# DIXIE-NARCO

## Service Bulletin # 162

MODELS: All Six (6) Product Adaptables, DN174-6, DN204-6, DN246-6  
All Five (5) Product Adaptables, DN100-5, DN145-5

SUBJECT: Addition of Vinyl Tubing to the Rear (only) of The  
Top Bale - - - Production Models

FIG. 1

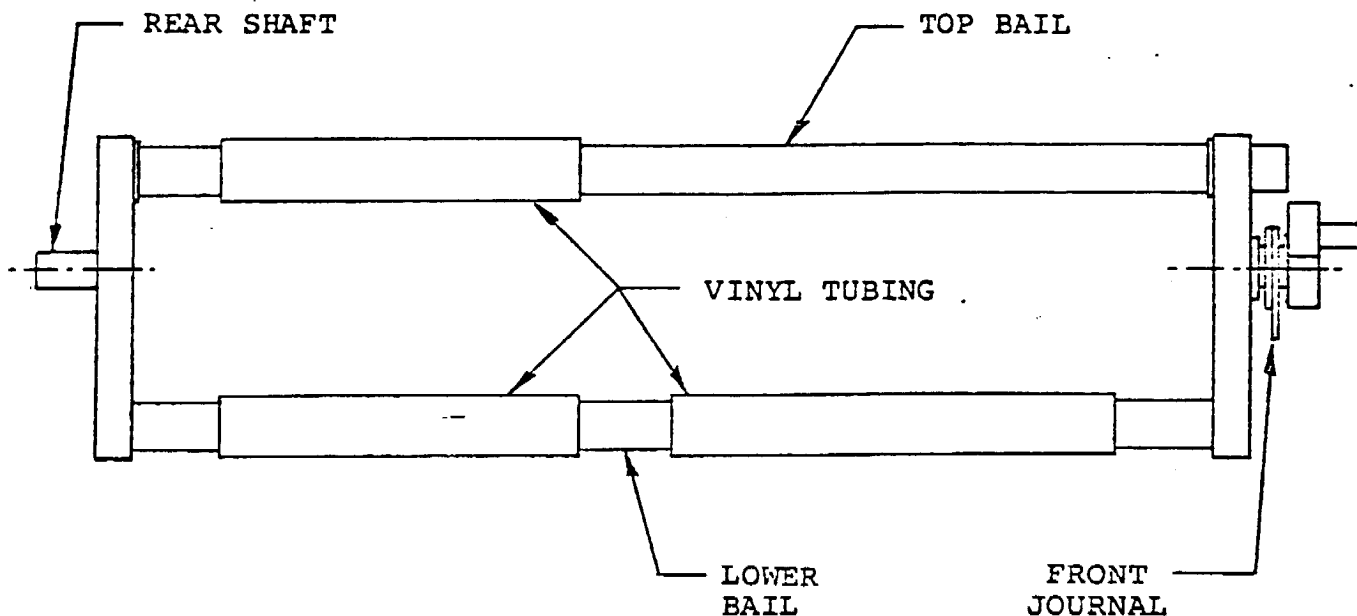
REASON: To provide a Vender on which the Vinyl Tube has been  
added to the Rear Section of the Top Bale - - - as shown  
in Fig. 1 - - - to decrease the likelihood of lower bale  
jams when dispensing "Rimless" cans.

<u>SERIAL NUMBER:</u>	<u>Serial Number</u>	<u>Model</u>	<u>Date</u>
	1792196	DN204-6	7/27/73

Effective on all subsequent Models of  
Adaptables with higher serial numbers.
